# Metropolitan Planning Commission

September 8, 2011

**165-79P-001**  
**RIVERGATE MARKETPLACE (PANDA EXPRESS)**  
 Map 026-15, Parcel(s) 001  
 Madison  
 10 – Doug Pardue

**2007SP-103G-06**  
**HARPETH SPRINGS VILLAGE (4-YEAR REVIEW)**  
 Map 141, Parcel(s) 088  
 Bellevue  
 22 - Sheri Weiner

**2011SP-018-001**  
 RHINO DISCOUNT MUFFLER (PRELIM & FINAL)  
 Map 050, Part of Parcel(s) 035  
 Parkwood - Union Hill  
 03 - Walter Hunt

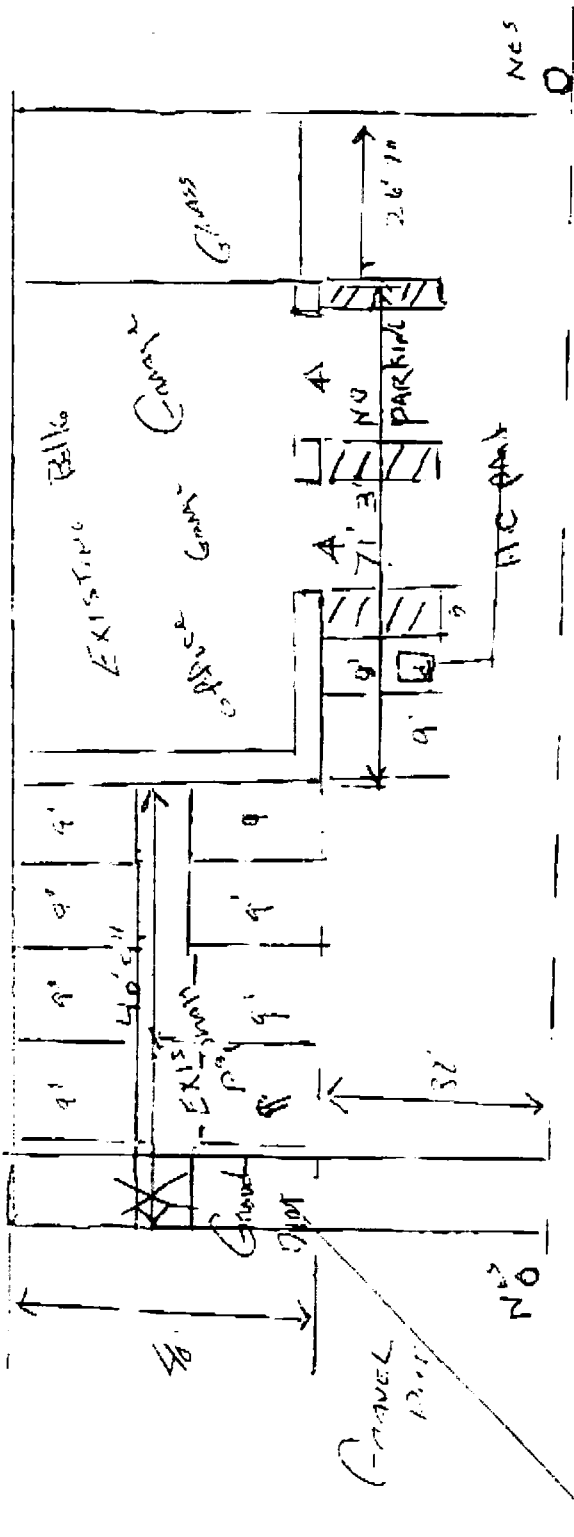
The applicant submitted a site plan with the SP application. The proposed parking layout does not demonstrate compliance with the parking requirements of the Zoning Code in either the layout of parking spaces or the overall number of parking spaces for the proposed spaces. The applicant intends to maintain the existing muffler business and add an auto sales use. According to the site plan, the applicant intends to do this without the

The site plan does not demonstrate the installation of other design elements that are generally required with auto-related SP requests. Because the site is located outside of the Urban Zoning Overlay (UZO) in an area that is generally less-urban than other auto SP proposals, inclusion of all of these design elements is not necessary. A condition of approval is proposed to limit any proposed ground signage to monument-style signs with a maximum height of six feet and maximum display area of 32 square feet.

- The developer's final construction drawings shall comply with the design regulations established by the Department of Public Works. Final design may vary based on field conditions.
- Show single driveway connection, not to exceed 24 ft.
- Show parking per Metro Code.

- Redesign parking to eliminate head in parking and to prevent backing into Dickerson Rd.
- Minimize open curb cut.
- Provide required parking per Metro Code.

2. Show a single driveway connection, not to exceed 24 ft. in width along Dickerson Pike.
3. Ground signs placed on the site shall be monument signs with a maximum of six feet in height and shall not exceed 32 square feet in display area.

4. Redesign parking to provide sufficient parking to meet the requirement of the Zoning Code for the proposed uses, to eliminate head-in parking, and to prevent backing into Dickerson Rd and minimize the curb cut. Final Parking layout shall be approved by Metro Planning Department staff and Public Works staff prior to the issuance of any permits.

**2006IN-001-003**  
 DAVID LIPSCOMB (NURSING & PHARMACY RESEARCH BUILDING)  
 Map 117-16, Parcel(s) 064-068, 079-081, 202, Part of 163  
 Green Hills - Midtown  
 25 - Sean McGuire

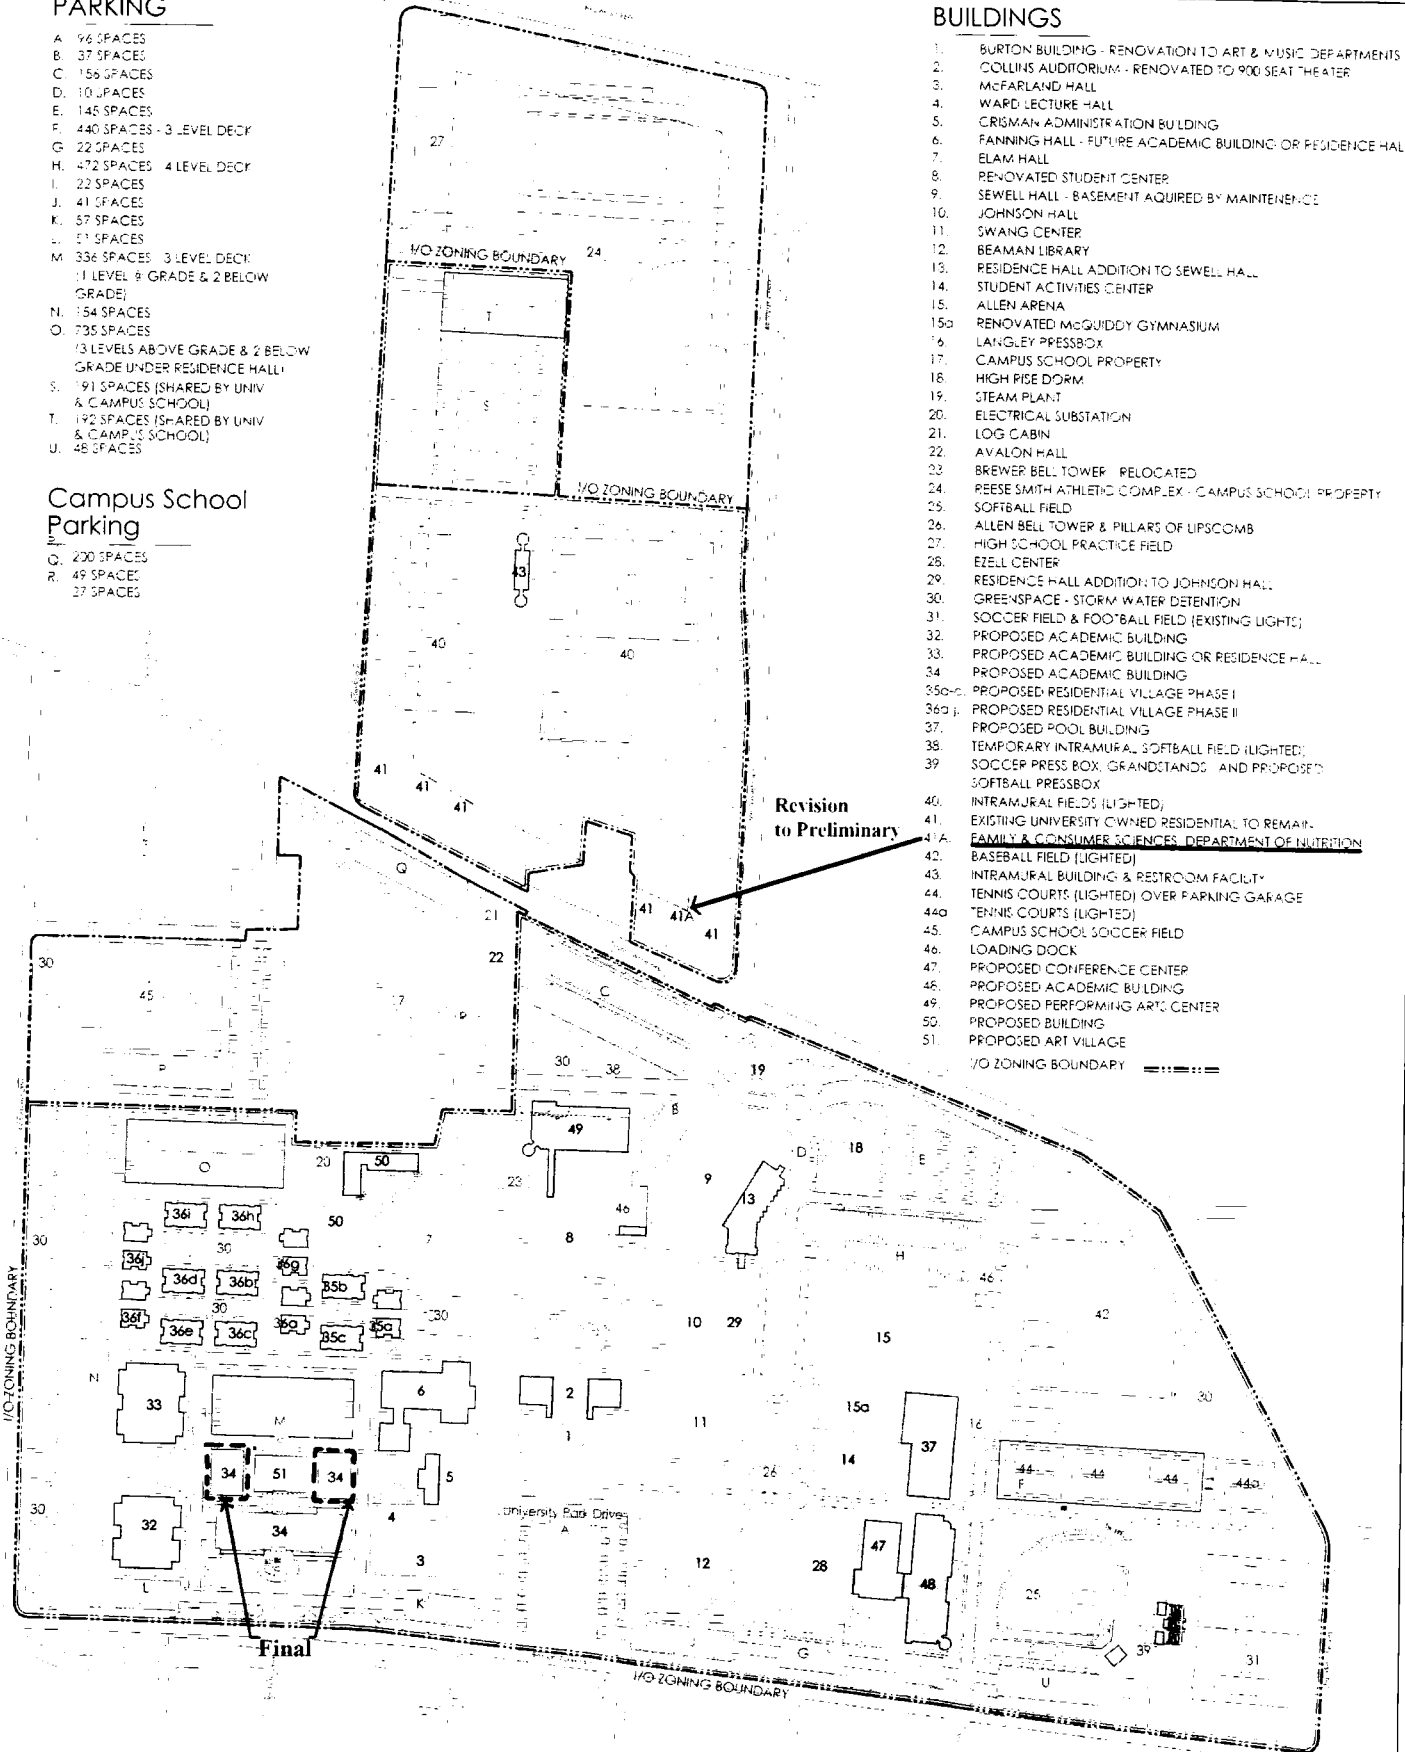
1. Developer/ Contractor to coordinate overhead power line removals on Crestview Drive with NES.
2. Developer to provide construction drawings and a digital .dwg file @ state plane coordinates that contains the civil site information (after approval by Metro Planning w/ any changes from other departments)
3. Developer drawing should show any and all existing utilities easements on property.
4. NES follows the National Fire Protection Association rules; Refer to NFPA 70 article 450-27; and NESC Section 15 - 152.A.2 for complete rules
5. NES needs load information and future plans or options to buy other property (over all plans).

- The developer's final construction drawings shall comply with the design regulations established by the Department of Public Works. Final design may vary based on field conditions.
- Show sidewalk improvements along Belmont.

- A 5 year update to the TIS has been scoped but not received.
- TIS shall be updated to include this project impact or a separate focused access study will be required to determine if previously approved master plan access drive opposite Glen Echo is required with proposed

Final Site Plan Returned (Stormwater):  
Sufficient plans for review been submitted. Stormwater requests approved plans prior to final site plan approval.

1. Prior to the issuance of any permits including grading and building permits, the proposal shall complete technical review with Metro Stormwater.
2. This approval does not include any signs. Signs in institutional overlay districts must be approved by the Metro Department of Codes Administration except in specific instances when the Metro Council directs the Metro Planning Commission to review such signs.

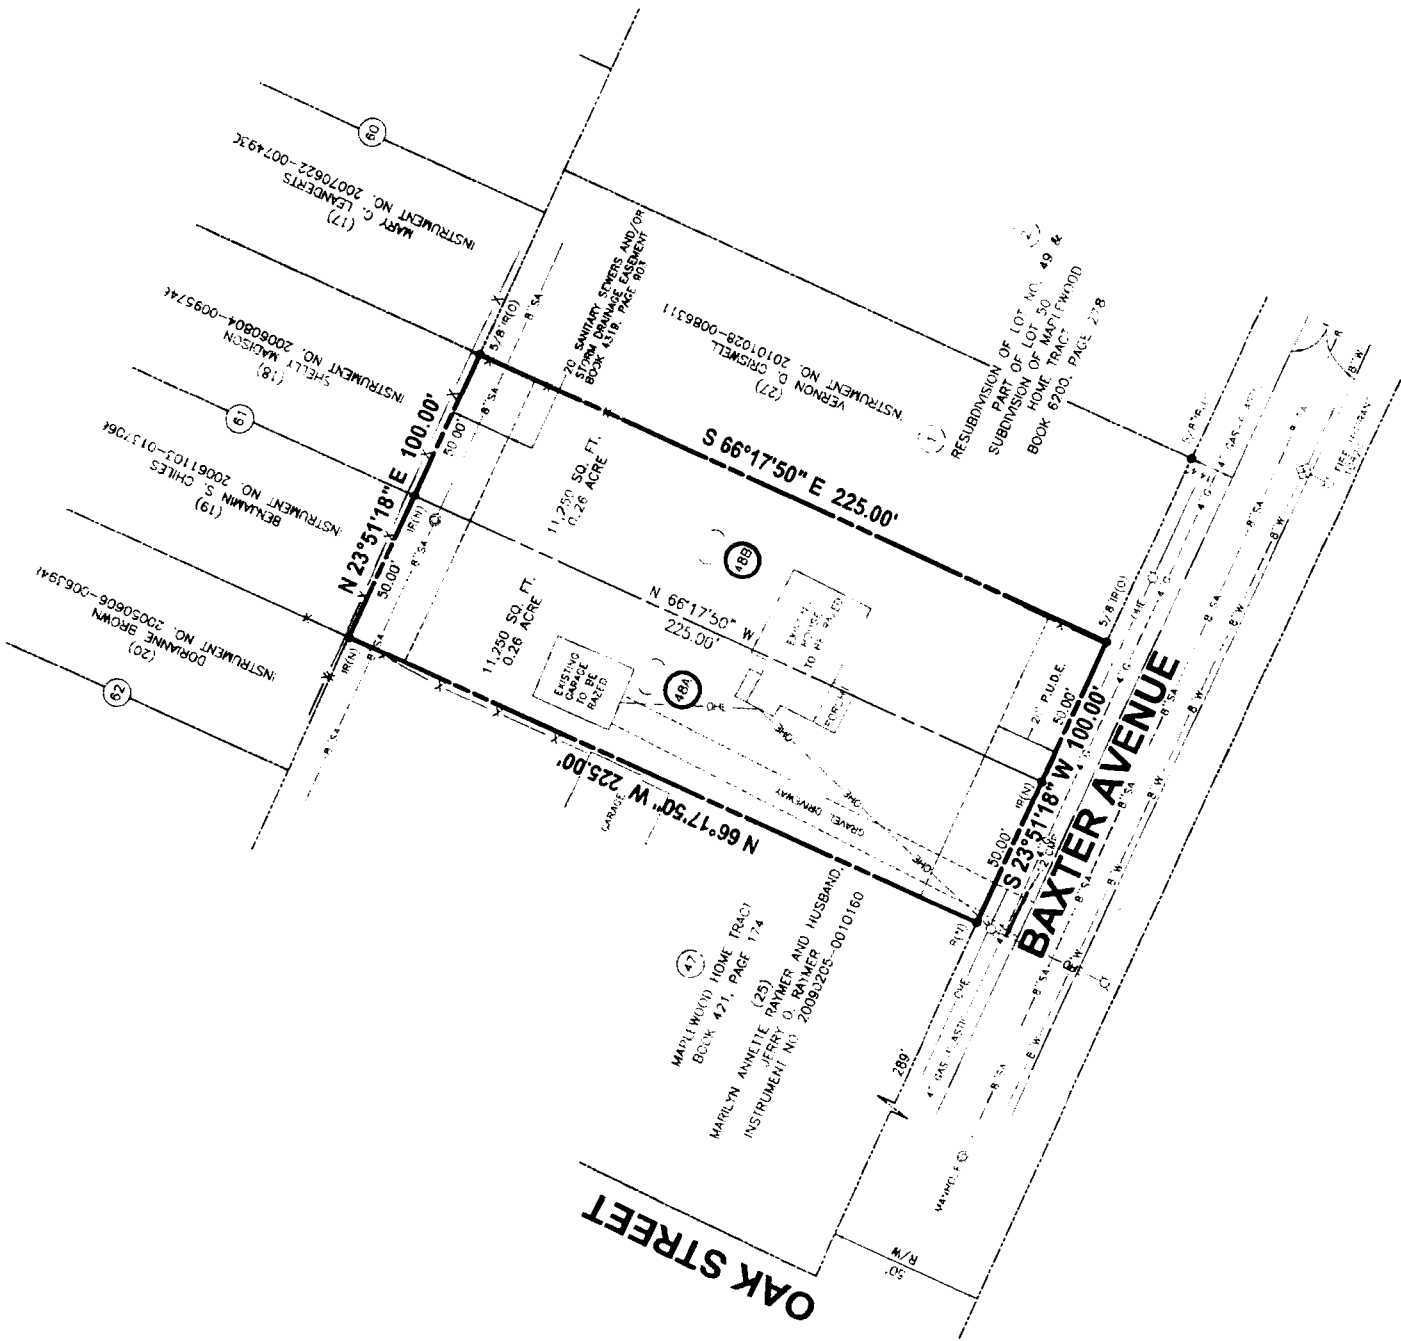
Section 3.8.2 of the Subdivision Regulations requires sidewalks on all existing streets abutting proposed subdivisions within the Urban Services District (USD). The applicant requests a variance to this requirement, stating that the construction of sidewalk along Baxter Avenue would provide no pedestrian benefit because it would not provide connections to other sidewalks on Baxter Avenue or on any cross streets. The variance application points out that the nearest existing sidewalk is located approximately 515 feet away on Gallatin Pike. Additionally, the applicant states that the “cost of constructing new sidewalk and drainage infrastructure on lot would provide no significant use to pedestrians.”

1. FEMA Panel Number and date are incorrect.
2. Add Access Note to plat.

1. Case No. 2011S-065-001 shall be added to the plat.
2. Building footprints shall be removed from the plat.
3. Sidewalk is required along the Baxter Avenue frontage of both lots for a length of 100 feet. One of the following actions shall be taken prior to final plat recordation:
  - a. Submit a bond application and post a bond with the Planning Department for construction of a sidewalk.
  - b. Submit payment in-lieu of construction to the Department of Public Works based on the required length of subdivision frontage on Baxter Avenue.
  - c. Construct sidewalk along the Baxter Avenue frontage of the subdivision and have it accepted by Public Works.

- d. Construct 100 feet of sidewalk within the same pedestrian benefit zone at a location in consultation with Public Works.
  - e. Add the following note to the plat: "No building permit is to be issued on any lot within this subdivision until the required sidewalk is constructed per the Department of Public Works specifications."
